STAFF REPORT

Re: <u>Mercer Mountain Estates – Final Subdivision Plat Request</u>

Application No.: 2025-0016-SUB

EXHIBIT F SUBDIVISION PLAT

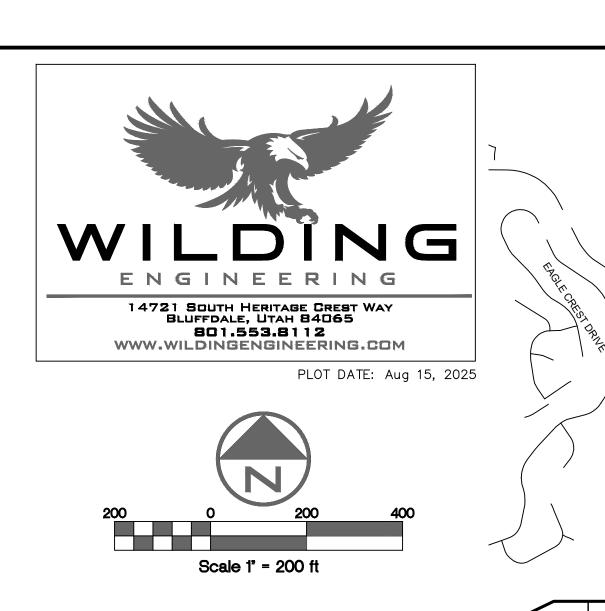
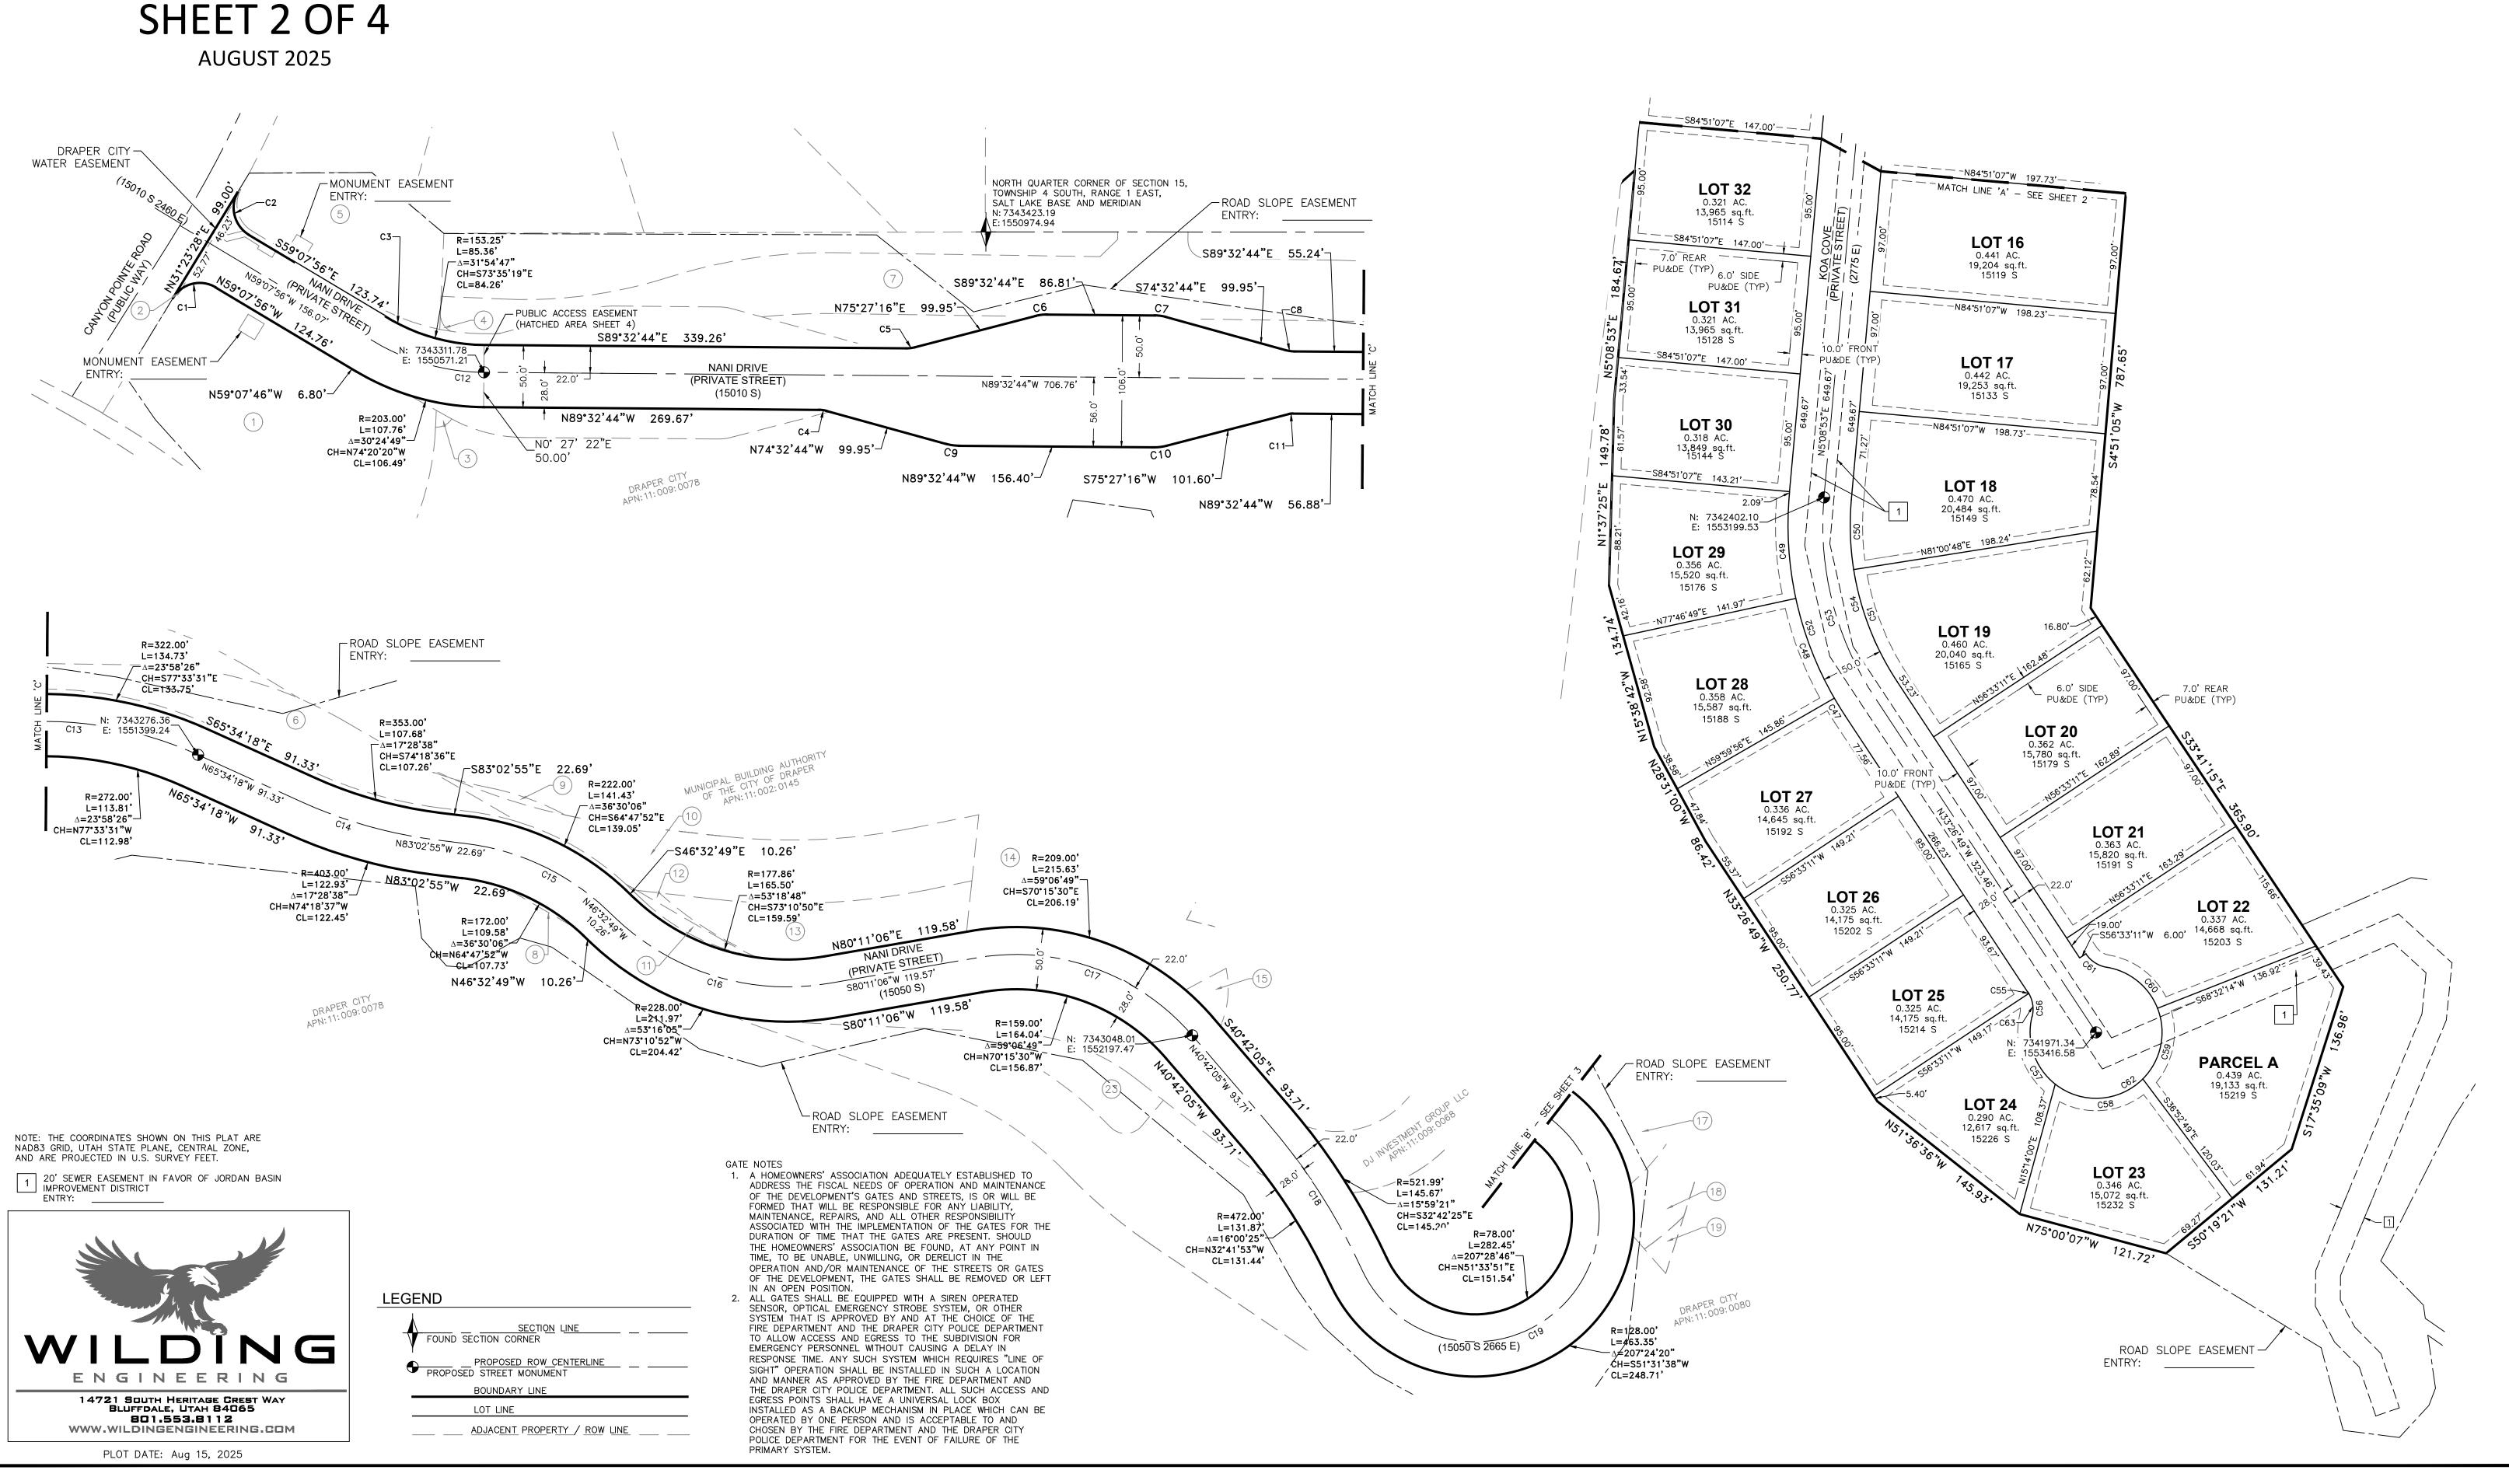
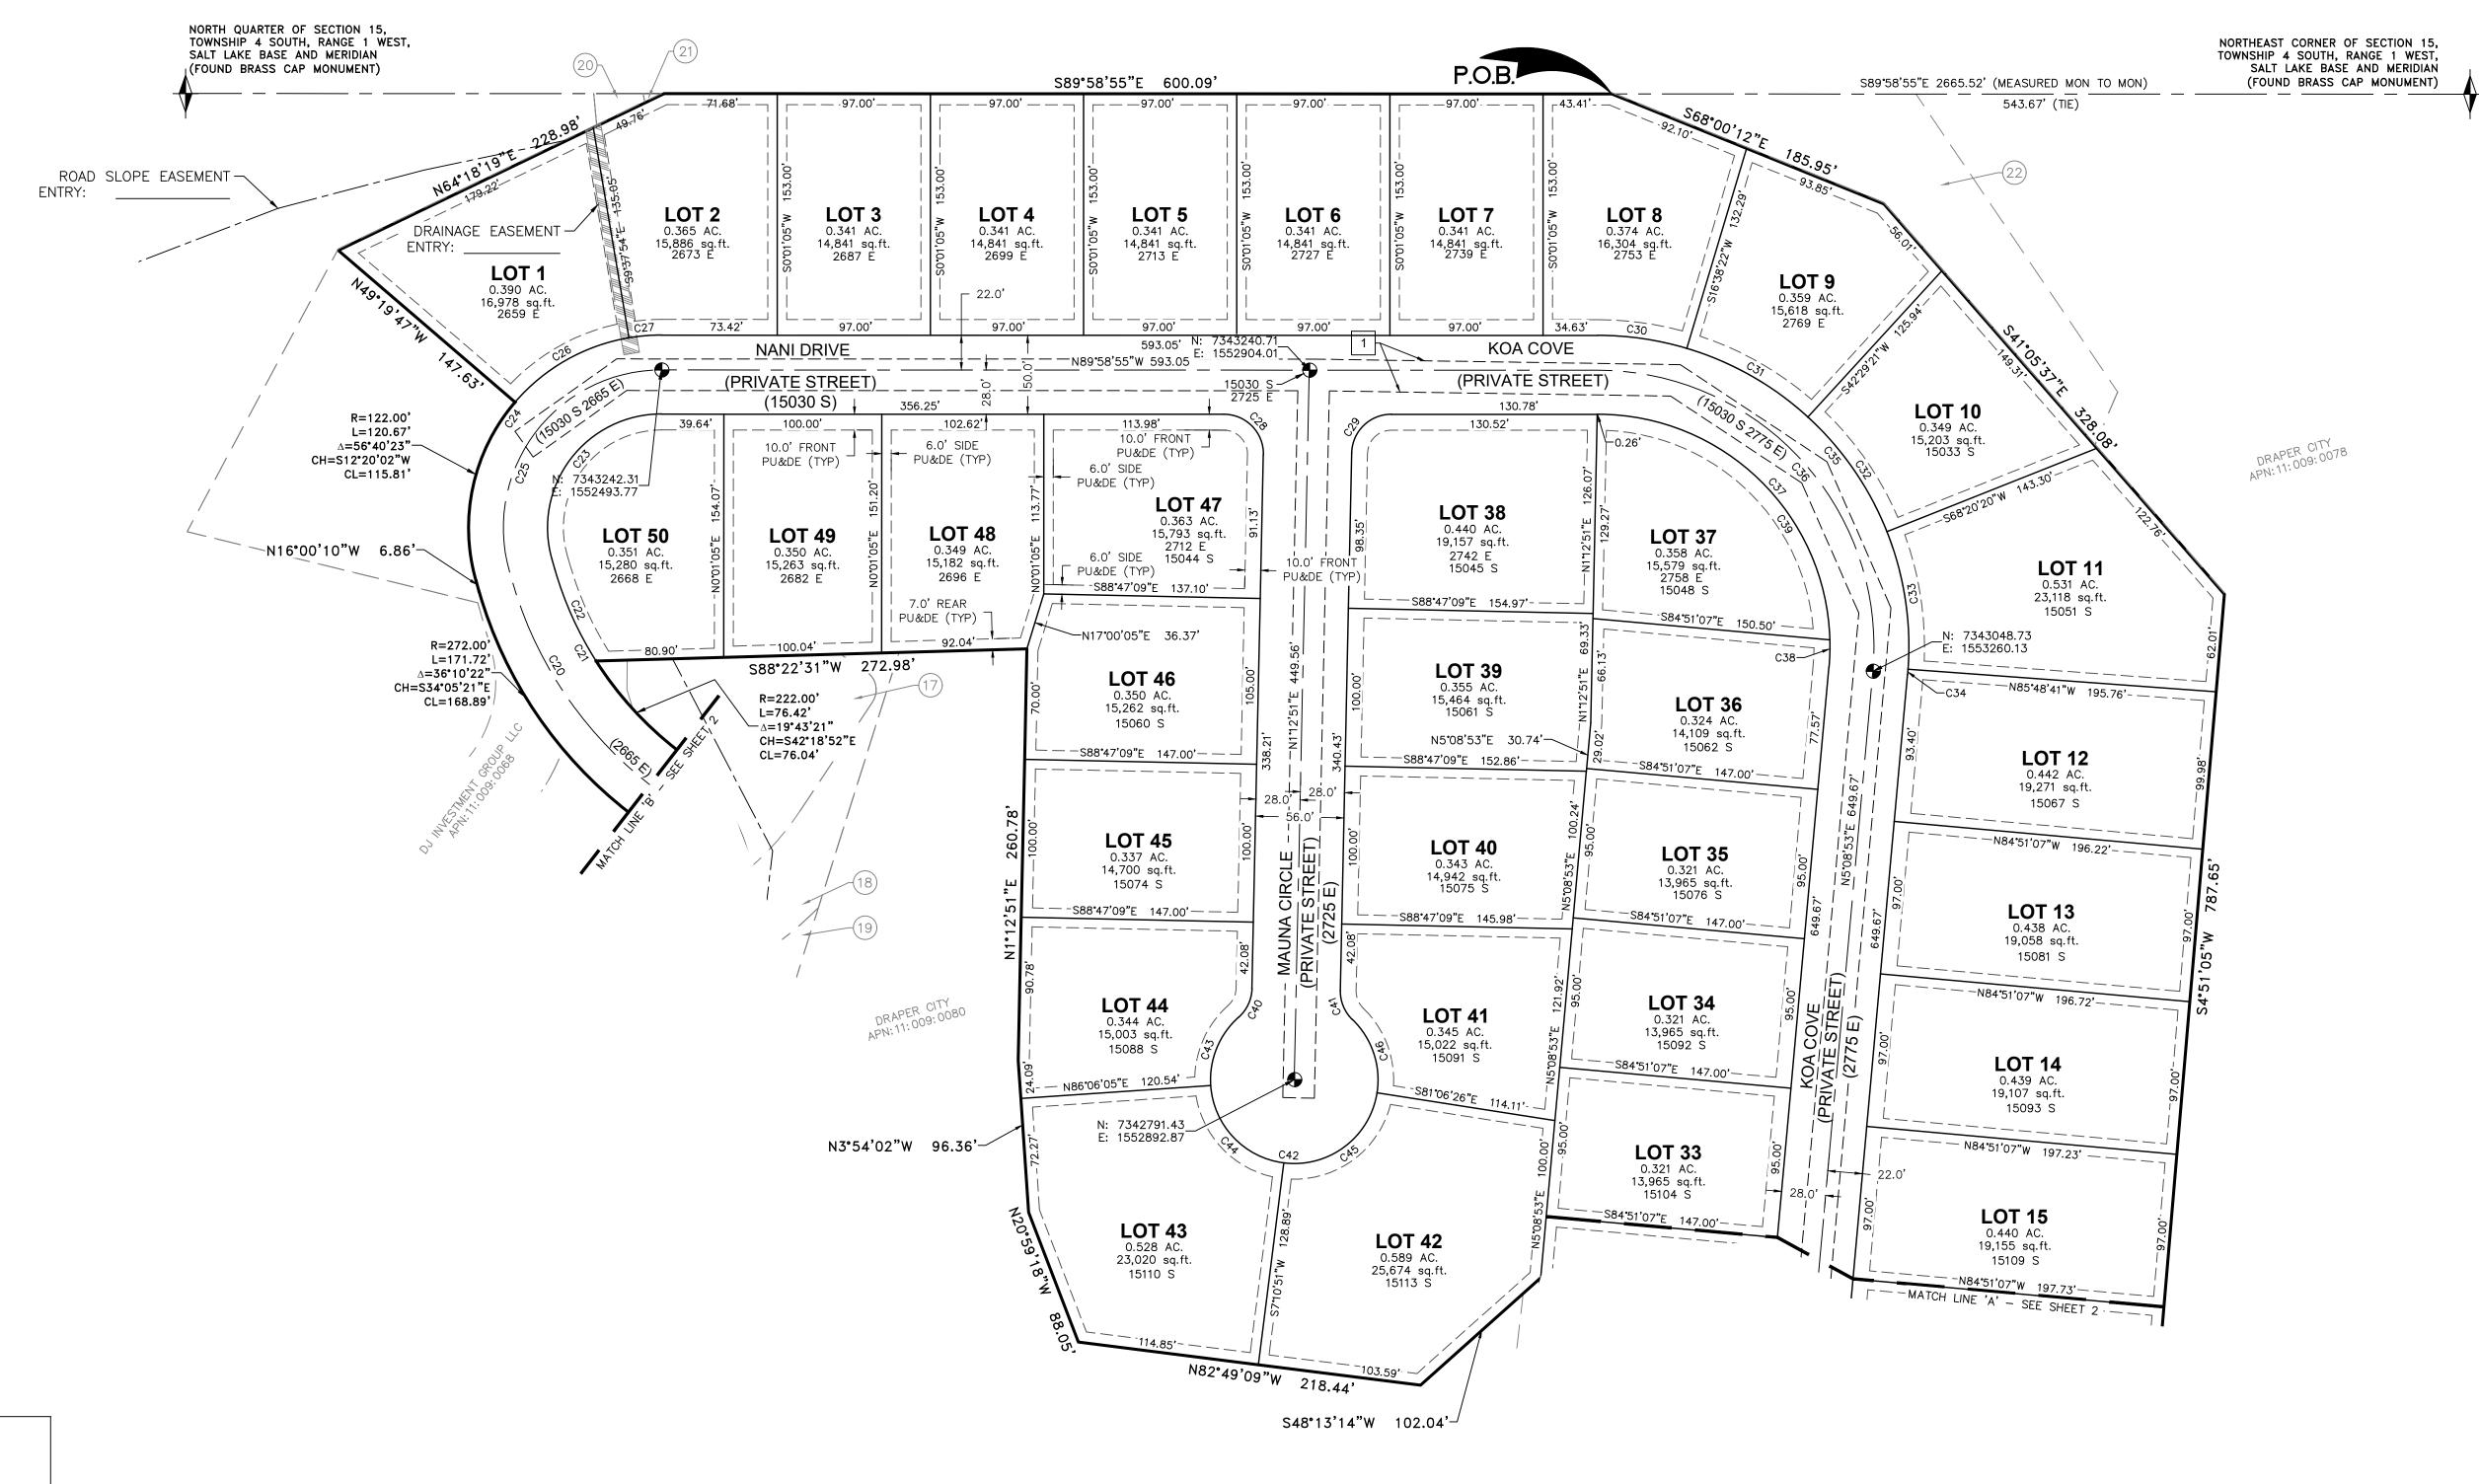
- 3. Owner's dedication is found at DCMC 17-4-030(N)(2). *Update dedication language to the dedication within city code.*
- 4. Add any drainage easement for swales crossing lots, as required by the drainage and grading plan per DCMC 17-5-040 and 18-3-150. Minimum easement width shall be 10 feet. Add **private** drainage swale between lots 1 and 2. Comment partially addressed update easement to **private** drainage easement.

- 5. The city waterline and meter vault easement be a minimum of width of 20 feet, centered on the pipeline from Canyon Pointe Rd and surrounding the master meter vault.
